SEWAGE DISPOSAL TESTING

STATE OF MARYLAND - DEPARTMENT OF HEALTH AND MENTAL HYGIENE

PROPERTY OWNER S. Ralph Dubrowin

ROAD AND DESCRIPTION Mink Hollow Road - opposite Richard Hallowell's property

Field sheet

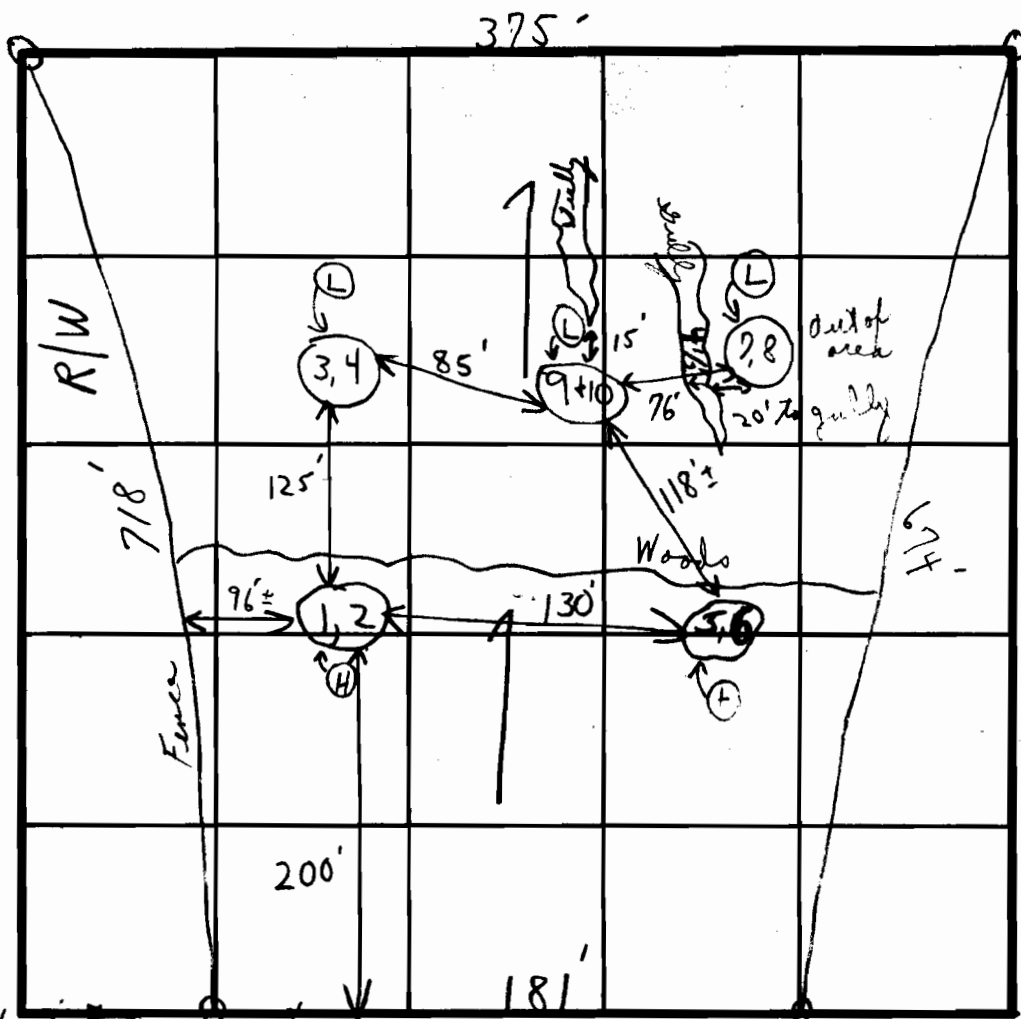
Tests not per stake

REMARKS: { Hold for certified? } 2 high holes in open { Hold for certified? }  
 holes C.B. 2 low holes in woods  
 TYPE OF SOIL: C.B.  
 TESTED BY: C.B.  
 ALSO PRESENT: Mr. Edwards, Mr. Dan Brown

Plat drawn by  
Claude Skinner  
May, 1959.

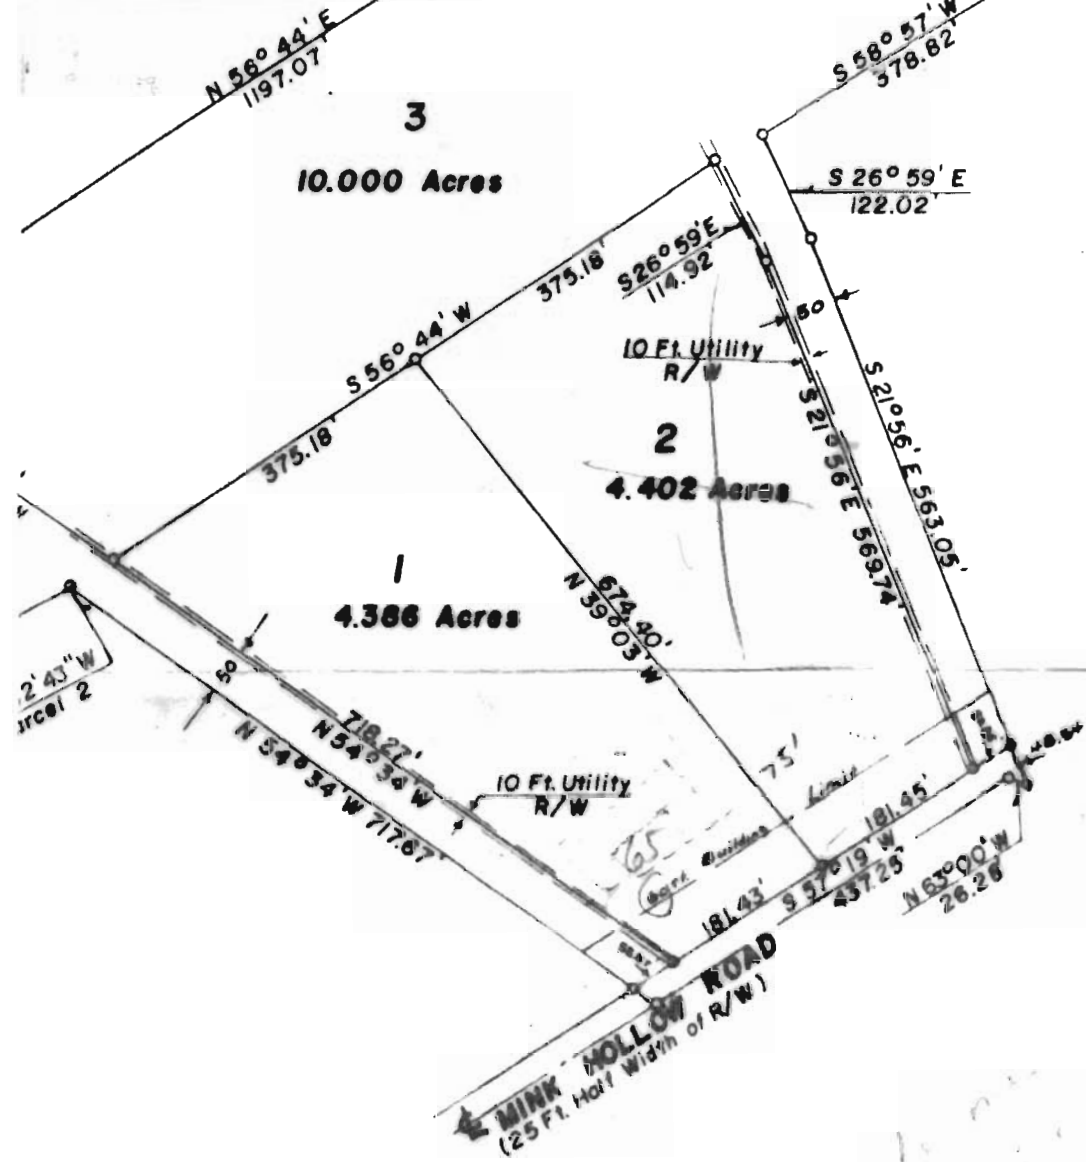
Discussed D.W.M. need to show as sewage disposal area  
with <sup>C.B.D.</sup> Holes (1, 2); (5, 6); (3, 4) + (9, 10) + confirm it is 10,000 sq ft.  
(S. RALPH DUBROWIN) <sub>only</sub> + no  $\pm$  C.B.D.  
P.M. Called need above corrections to Mr. Fisher C.B.D.
